Product Change Notice (PCN)

PCN Number: **PCN-0451130R-01**

Product(s) Affected: **PJ-031CH**

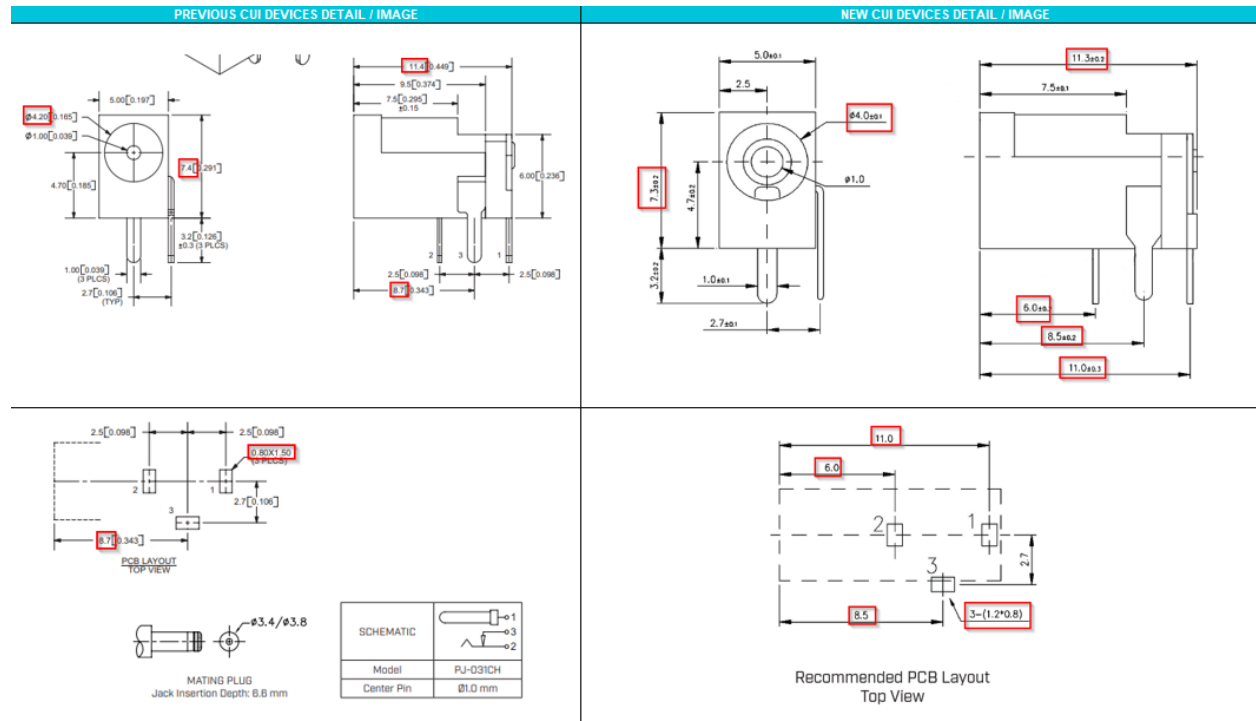
Description of Change: **Mechanical, electrical, and material changes as shown below:**

MATERIAL	PLATING
center pin	copper	nickel
terminal 1	brass	silver
terminal 2	copper alloy	silver
terminal 3	brass	silver
plastic	PBT

DESCRIPTION	MATERIAL	PLATING/COLOR
center pin	brass	silver
terminal 1	brass t=0.50	silver
terminal 2	MM alloy t=0.20	silver
terminal 3	brass t=0.50	silver
housing	PA10T (UL94V-0)	black
